**DRAFT CAMELLIA TOWN CENTRE MASTER PLAN
SUBMISSION**

This submission has been prepared by *KEYLAN Consulting Pty Ltd* (KEYLAN) in collaboration with *Allen Jack + Cottier Architects* (AJ+C) on behalf of The Billbergia Group in response to the Department of Planning and Environment's (DP&E) *Draft Camellia Town Centre Master Plan* (Draft Plan) which is currently on public exhibition until 29 March 2018.

Figure 2: Comparison of Sydney’s town centres (Source: Hill Thalys Architecture + Urban Projects)

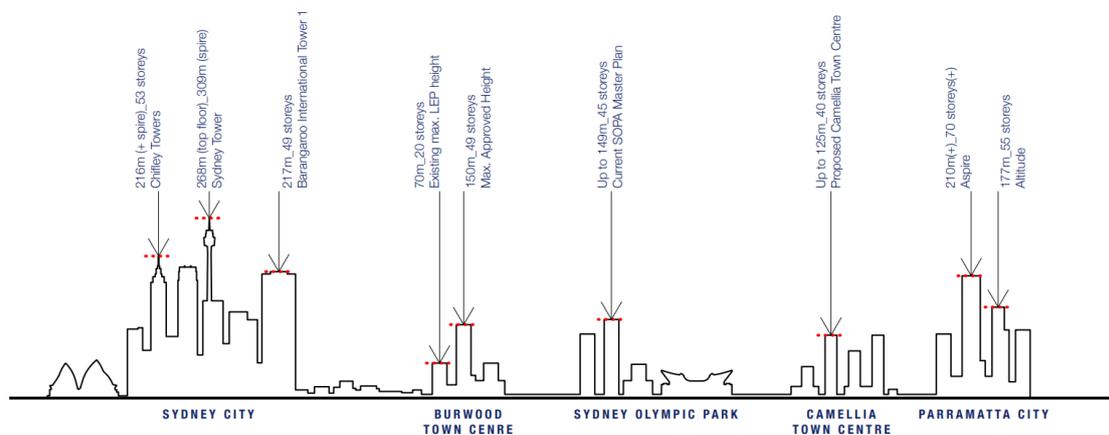
We also recognise the comparable status of Burwood Town Centre and Sydney Olympic Park with Camellia and the hierarchy of Sydney’s town centres. However, we contend that some of the proposed planning provisions for the Town Centre are more restrictive than other supporting town centres and may not enable delivery of the centre given the existing constraints.

As detailed in this submission, our analysis demonstrates that the Town Centre has the potential of providing more dwellings and employment opportunities to ensure the delivery of the Government’s aspirations for the precinct.

That the built form controls in the Draft Plan be revised to allow the Town Centre to achieve its role in the city hierarchy.

Figure 4: Proposed FSR in the Draft Plan (Site outlined in red) (Source: DP&E)

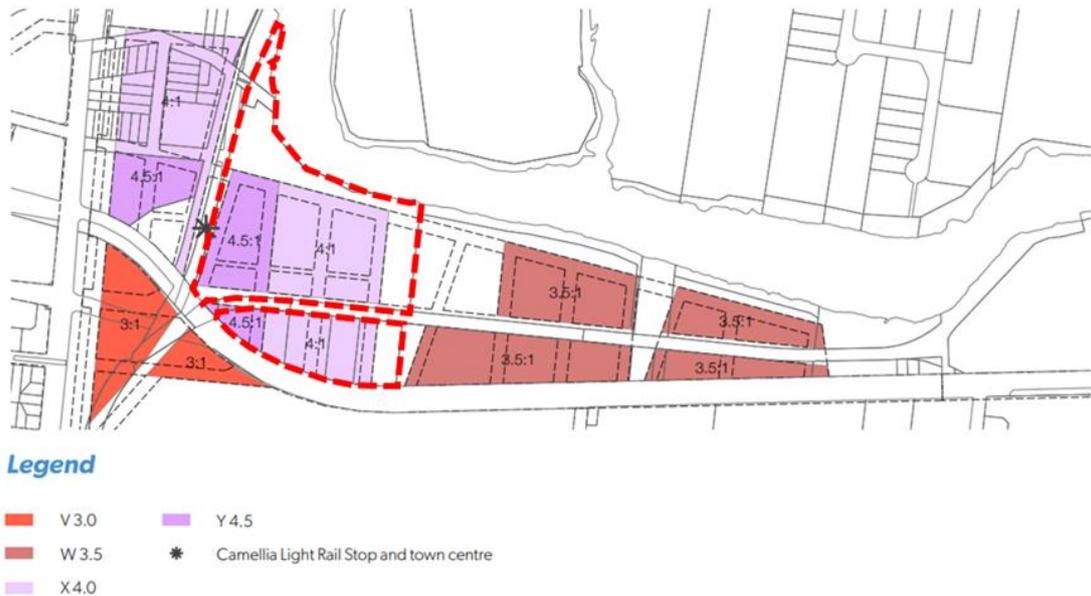
We note that the while Draft Plan proposes FSRs of 4.5:1 and 4:1 over 64% of the Billbergia site (Figure 4), the other 36% is given an FSR of zero. The average FSR over the developable area is 4.21:1 and results in an approximate gross floor area (GFA) of 261,278 m².

Based on the analysis by AJ+C, the street layout and built form controls of the Draft Plan prevent the Billbergia properties from achieving their allocated FSRs.

AJ+C's analysis concludes that the 85% building efficiency used in the Draft Plan is too high, exceeding the 70-75% range established in the *Apartment Design Guide* (ADG), leading to an inflated unit count.

At high efficiencies of 90% gross envelope area (GEA) to GFA for commercial/retail and 75% for residential, the Draft Plan gives an achievable GFA of approximately 225,000m² equating to an FSR of 3.63. This is significantly less than the 4.21:1 allocated and will substantially reduce the potential yields for the site.

It is important to note that the Draft Plan disregards the existing property boundaries in the allocation of FSR. When averaged over the entire Billbergia site, the FSR falls to 2.34:1. This results in an FSR below current planning controls for some sites, leaving little incentive for redevelopment.

That FSR be allocated over the whole site, including proposed open space and road areas, to provide flexibility and to allow the reallocation of FSR on developable land.
